INSPECTION NOTES - July 21, 1982

Re: Acme Scrap
Ashtabula County
Industrial Wastewater

INSPECTION NOTES

Acme Scrap Oil Retention Lagoon.

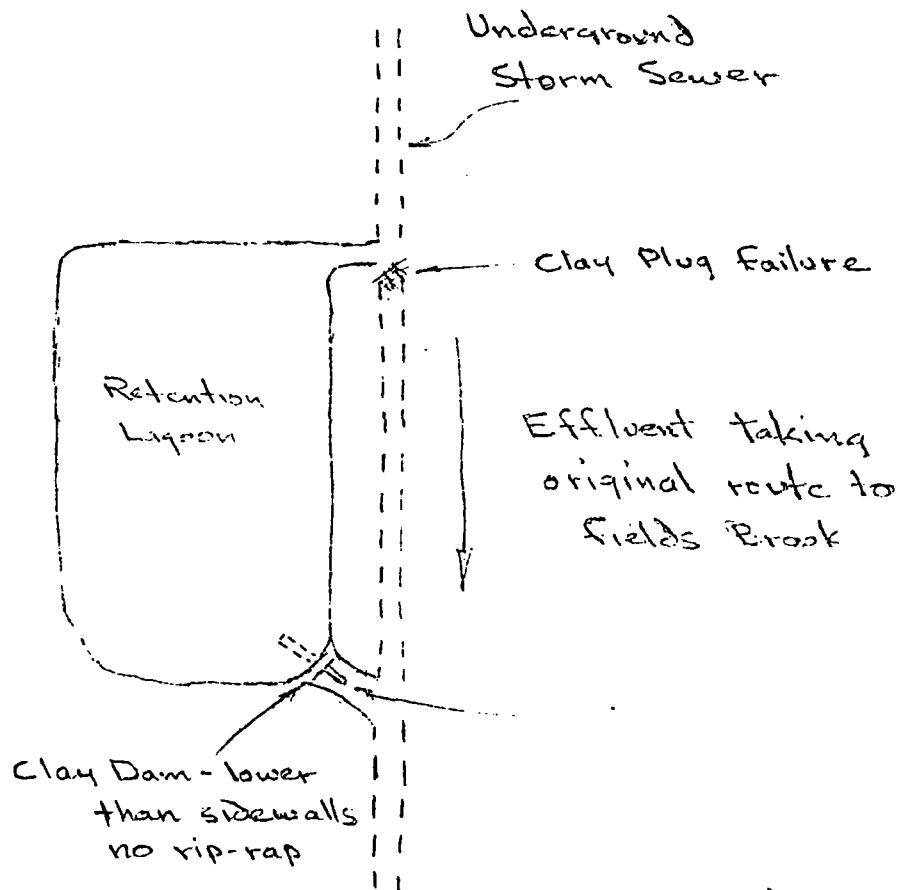
Lagoon observed. Slight oil sheen on it at influent end. Lagoon facility improperly constructed as inflow was bypassing lagoon and entering original discharge route. Also dam at effluent end did not contain rip-rap as a protective cover and was lower in elevation than the rest of the pond so it could serve as a spillway should levels ever get that high. See attached drawing, Sam Simon informed of findings. Larry Tackett shown problems. Explained to him that remaining storm sewer that allows bypassing has to be removed and properly back-filled or adequately plugged with concrete.

Also explained that dam had to be raised so that if levels got to the overflow point, any discharge or spill would spread out over the adjacent field area rather than go immediately down the storm sewer. Explained the need for rip-rap too. Simon and Tackett agreed they could accomplish above by the end of the following week. I asked them to send me a letter confirming the completion of such work. Simon said he would.

Follow-up telephone conversation to Simon on June 18, 1982. He said storm sewer had been broken into and plugged with blue clay. Had held during recent heavy rains. Dam not yet raised or rip-rap placed. He will talk to Tackett to whom I explained what to do.

Lagoon reportedly contains very small amount of oil.
